Office Action Summary

10/823,878

VOGRIG ET AL.

DETAILED ACTION

Fig 9, Musil US Pub 2004/0045136.

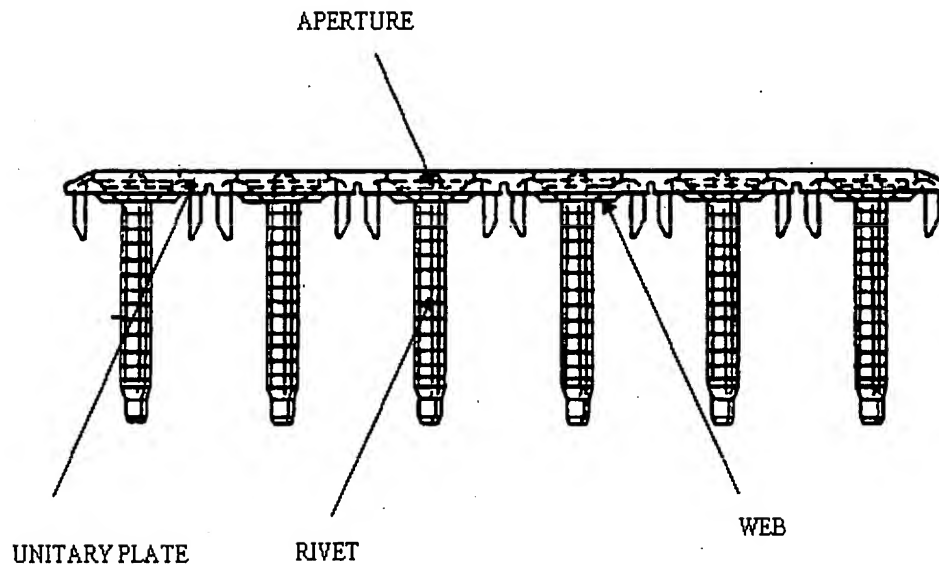
With respect to claim 1, Musil Fig 2 and Fig 9 discloses a unitary plate body of a predetermined thickness and having an upper surface and a lower surface spaced by the predetermined thickness of the body; a plurality of rivets having preformed rivet heads including top surfaces that are aligned with each other; a plurality of apertures of the unitary plate configured to support the rivets depending from the plate so that the top surfaces of the rivet heads do not project above the upper surface of the plate body, and the rivet head top surfaces are closer to the lower surface than the upper surface of the plate body.

With respect to claim 2, Musil discloses that the plate predetermined thickness is sized to receive the preformed heads of the rivets (Fig 9).

With respect to claim 6, Musil discloses that the plate includes portions above and generally below the heads of the rivets in the apertures to capture the heads therein (Fig 9).
